1
AMENDMENT 1
- REMOVE CRUSHER FINES BIKE PATH
- ADDED TURN LAND AND ROAD INTERSECTION INTO GVR FILING 18
- PLANTING ADDED TO CURBSIDE

2
AMENDMENT 2
- PLANTING REVISED
- RECEPTION NUMBERS ADDED

TIBET ROAD (TRIBUTARY T TO E. 48TH AVE.) AMENDMENT 2
SITE PLAN FOR INFRASTRUCTURE
TITLE: LANDSCAPE PLAN
DATE: June 5, 2024

TIBET ROAD (TRIBUTARY T TO E. 48TH AVE.) AMENDMENT 2
SITE PLAN FOR INFRASTRUCTURE
TITLE: LANDSCAPE PLAN
DATE: June 5, 2024

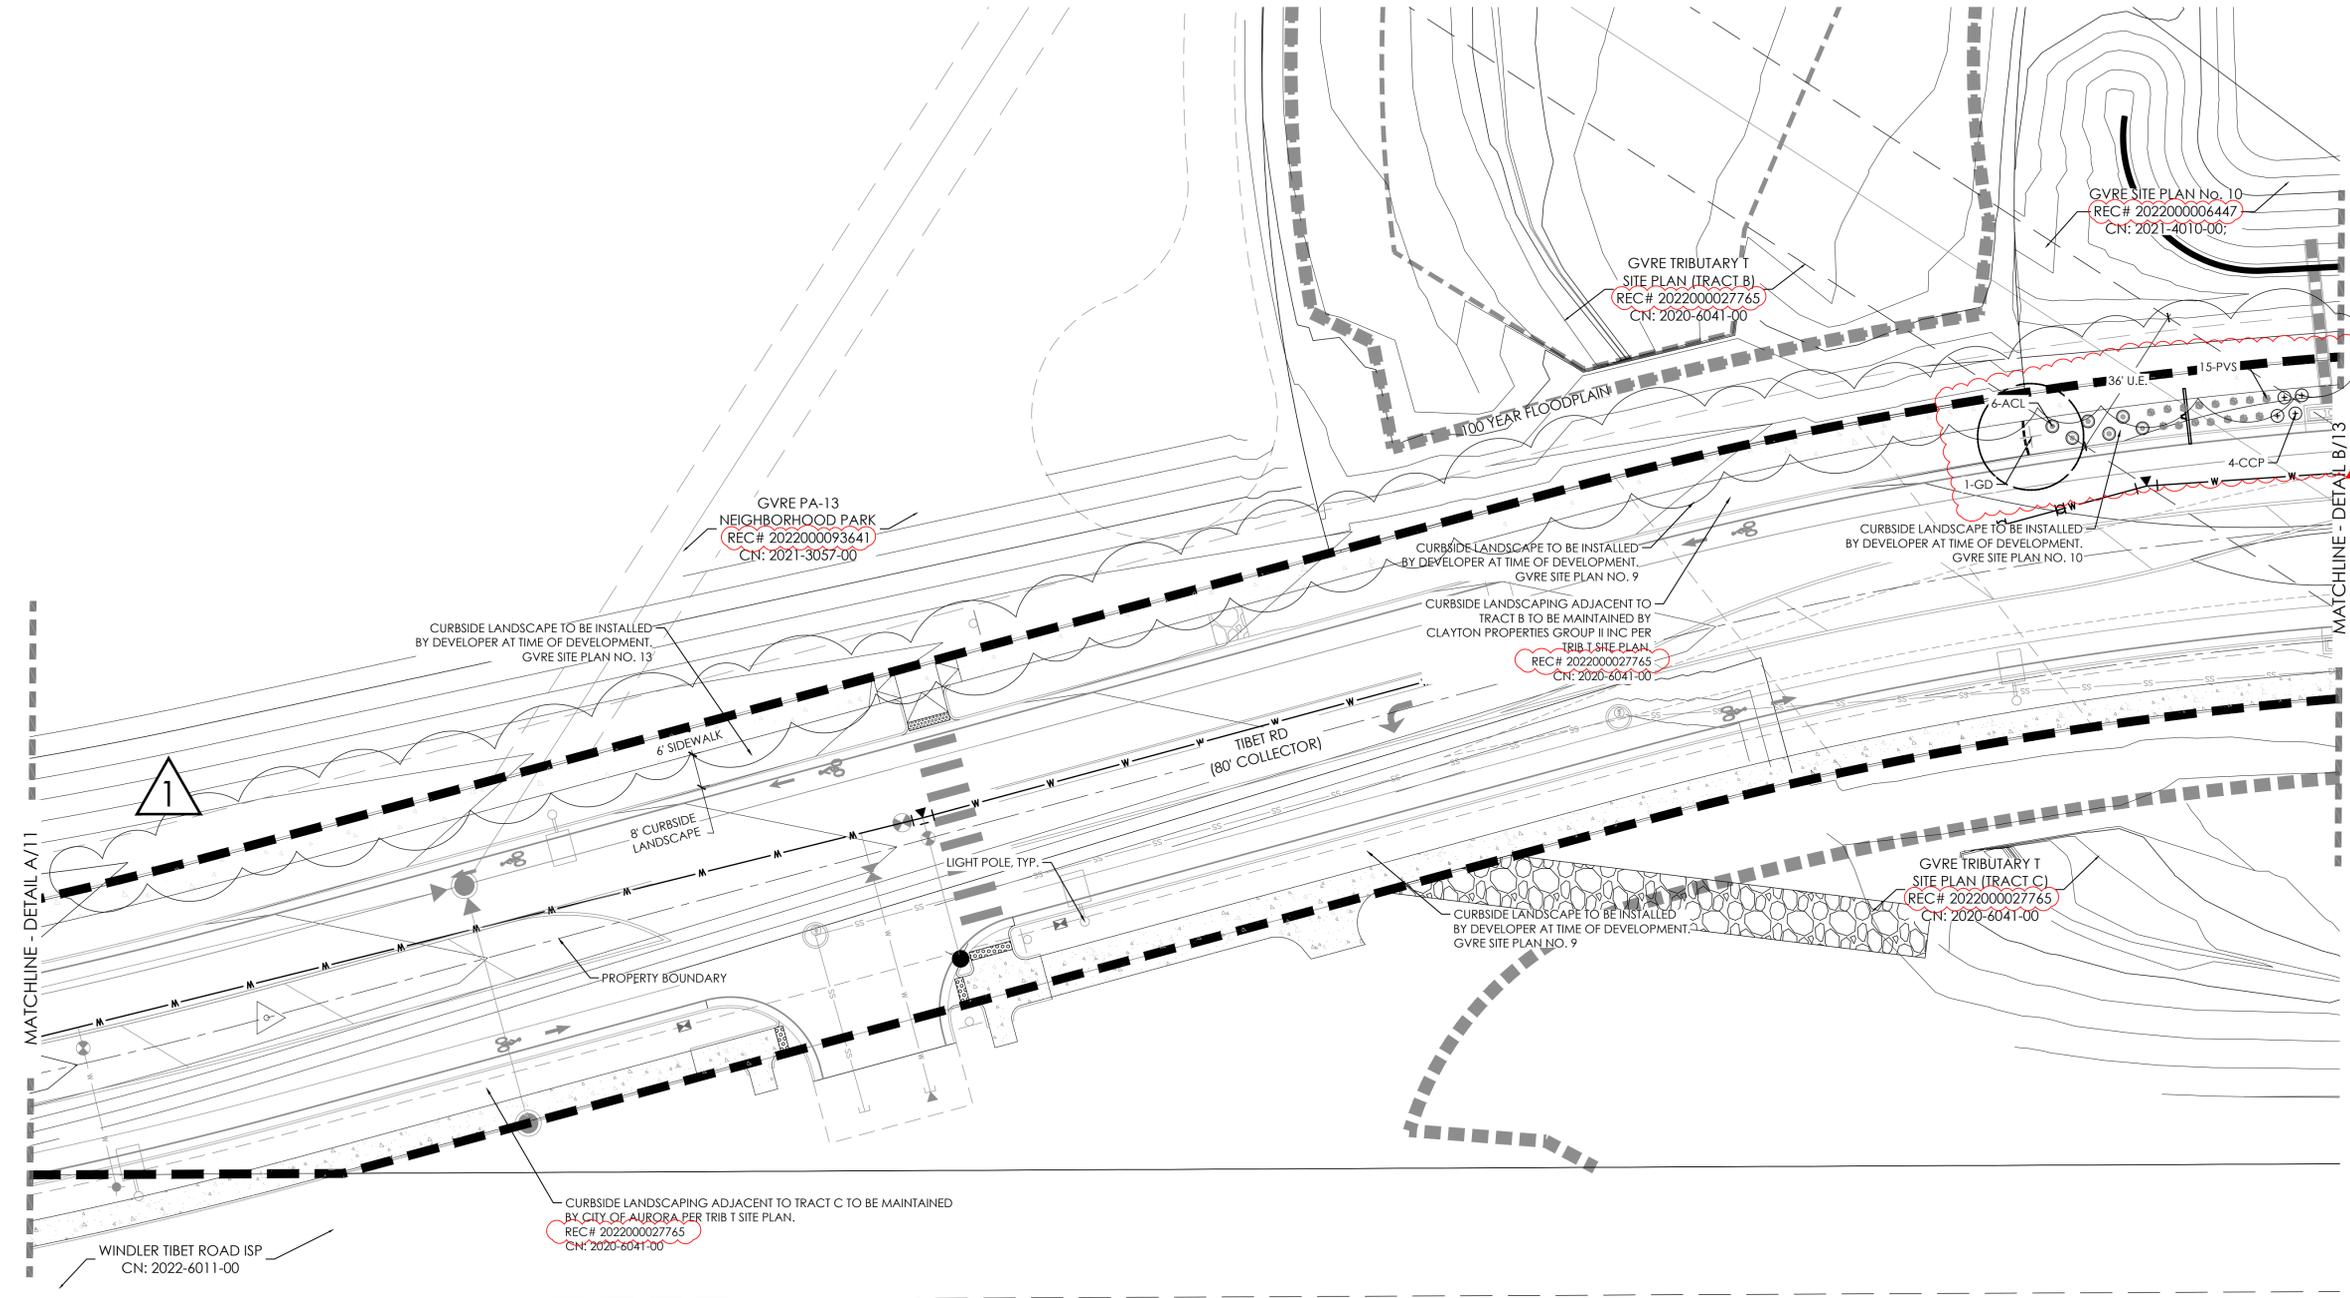
1
AMENDMENT 1
- REMOVE CRUSHER FINES BIKE PATH

2
AMENDMENT 2
- PLANTING REVISED
- RECEPTION NUMBERS ADDED

TIBET ROAD (TRIBUTARY TO E. 48TH AVE.) AMENDMENT 2
 SITE PLAN FOR INFRASTRUCTURE
 TITLE: LANDSCAPE PLAN
 DATE: June 5, 2024

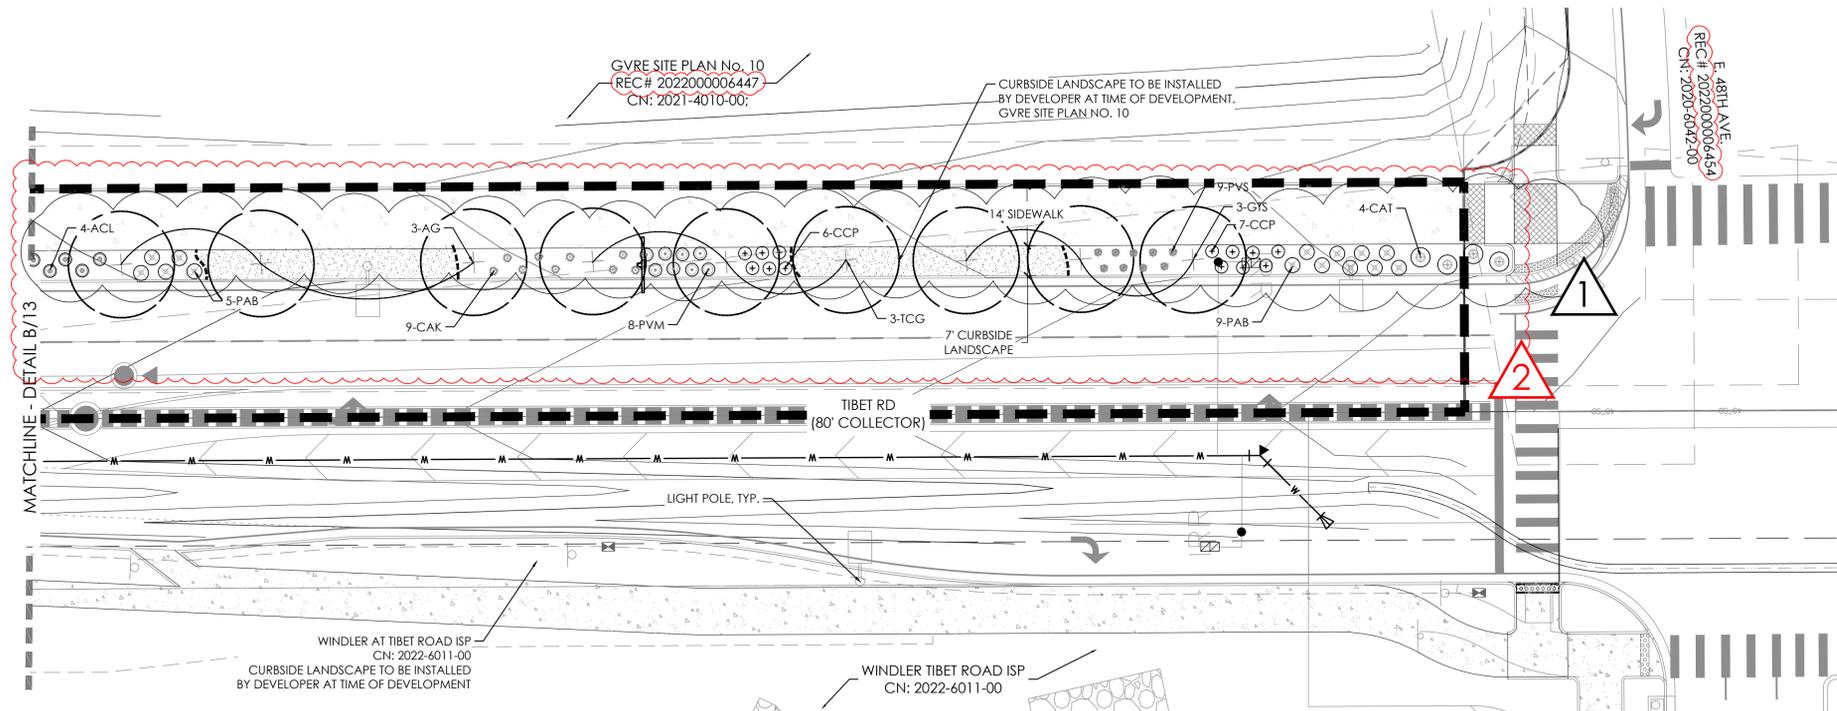
AMENDMENT 1
 - REMOVE CRUSHER FINES BIKE PATH

AMENDMENT 2
 - PLANTING REVISED
 - REMOVED ACCESS POINT INTO GVRE FILING 10
 - ADDED AN ADDITIONAL TRAVEL LANE ON THE WEST SIDE OF TIBET ROAD
 - BIKE LANE COMBINED WITH SIDEWALK TO MAKE A 14' SHARED WALK
 - RECEPTION NUMBERS ADDED
